Energy National Technical Specification Notice

ENE NTSN – Technical Annex

Draft for preliminary consultation based on the [NTSN published on 1st January 2021](#) with the [ERA proposals for the TSI 2022 package \(Digital Rail and Green Freight\)](#) shown as changes to this. The markup reflects the proposed TSI text, except where this has been amended for applicability to GB, such as substituting 'NTSN' for 'TSI'. Please note, this draft may still include TSI proposals which need to be further amended where text is not applicable to GB.

Figure D.2

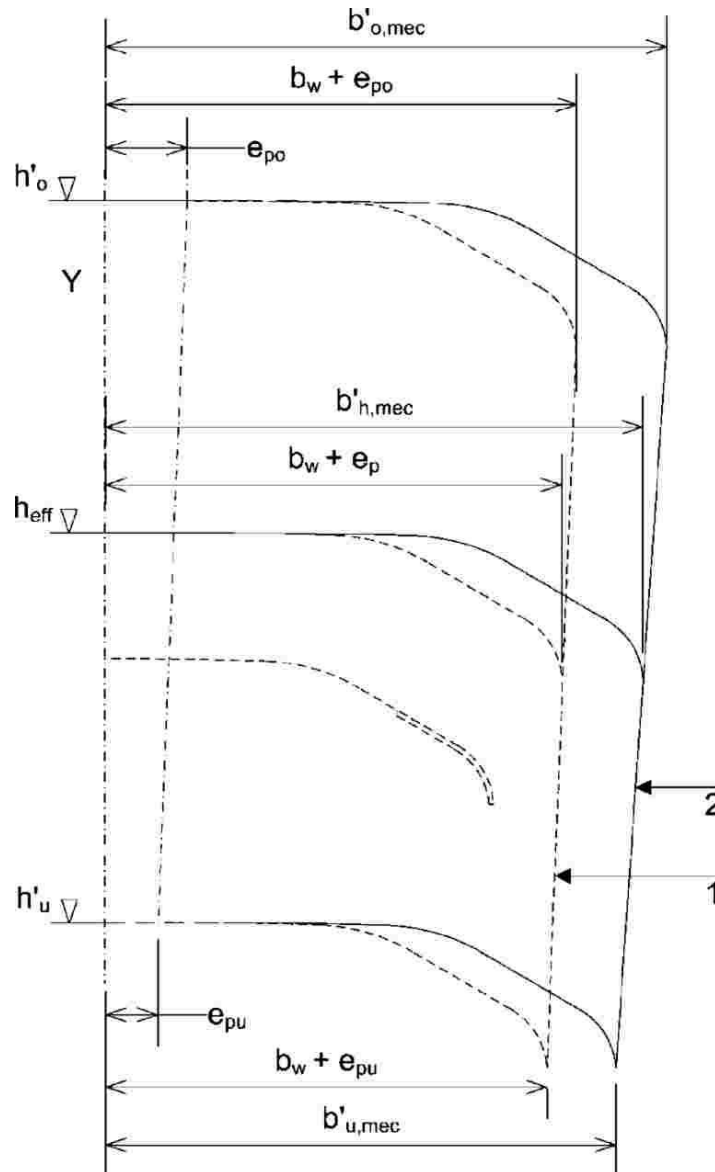
- (1) No part of the energy sub-system shall enter the mechanical kinematic pantograph gauge (see Appendix D figure D.2) except for the contact wire and steady arm.
- (2) The mechanical kinematic pantograph gauge for interoperable lines ~~shall be is~~ specified using the method ~~shown in Appendix D.1.2~~ [given in the specification referenced in Appendix E, index \[2\]](#) and the pantograph profiles defined in LOC&PAS NTSN, ~~points~~ [clauses](#) 4.2.8.2.9.2.1 and 4.2.8.2.9.2.2.
- ~~(3) This gauge shall be calculated using a kinematic method, with values:~~
 - ~~(a) for the pantograph sway e_{pu} of 0,110 m at the lower verification height $h'u = 5,0$ m and~~

~~(b) — for the pantograph sway σ_{po} of 0,170 m at the upper verification height $h'_{o} = 6,5$ m,~~

~~in accordance with point D.1.2.1.4 of Appendix D and other values in accordance with point D.1.3 of Appendix D.~~
